NAYEM KNITWEAR LTD - Extension (Previously UNION KNITTING AND DYEING LTD)

25 September 2024

2. Observations:

Live load table (BNBC part 6)

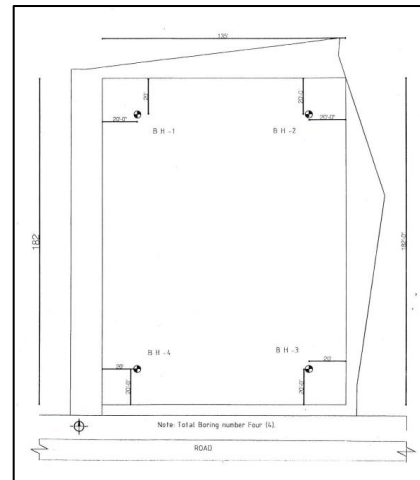
Observation-1: Storage live load does not comply with BNBC requirements. (Factory Building (New))

Description: The live load on the storage area of the 1st floor is considered 3 kPa (63 PSF) in the prepared load plan. As per BNBC-2006, the live load for light storage areas is required to be considered a minimum of 6 kPa. The building engineer is required to revise the load plan as per BNBC requirement and check the design accordingly.

Dampness on roof slab

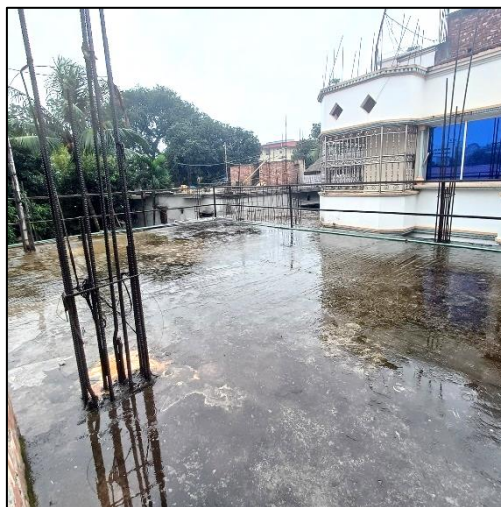
Observation-7: Dampness on roof slab and brick wall. (Dinning Building)

Description: Dampness found on roof slab and brick wall of Dinning Building. The building engineer is required to investigate the cause of dampness and repair with a suitable method.
